Service Information

MX-M3050/M3550/M4050/M5050/M6050, MX-M3070/M3570/M4070/M5070/M6070, MX-M2630, MX-M2651/M3051/M3551/M4051/M5051/M6051, MX-M3071/M3571/M4071/M5071/M6071, MX-M6570/M7570

CHANGE OF HDD

Location (Excerpt from **V21** PWB section 2 in Parts Guide for MX-M2651 series)

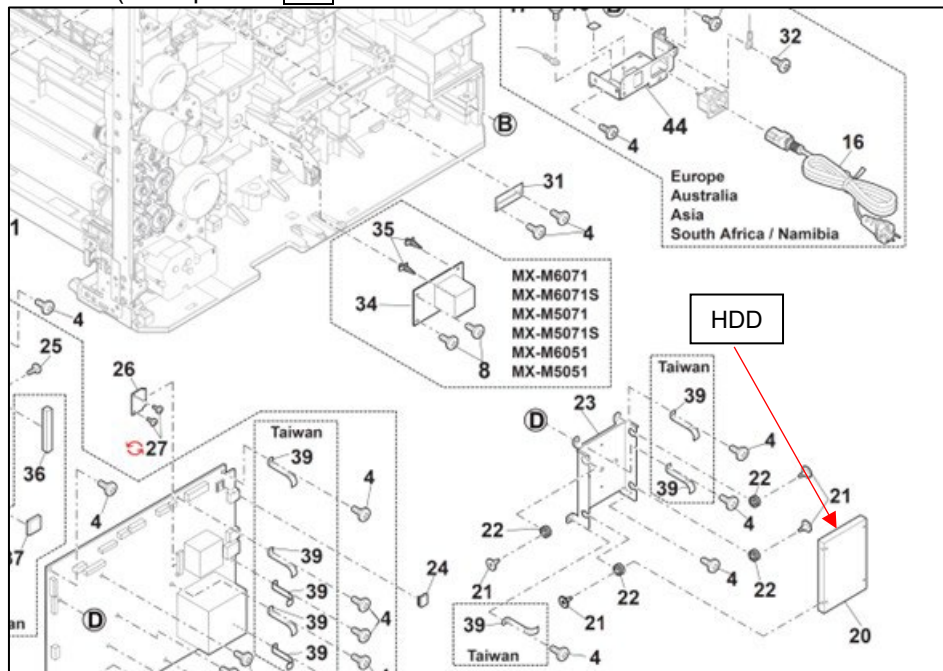
HDD usable for above models has been registered as service part to stabilize parts supply.

*There is no visible difference.
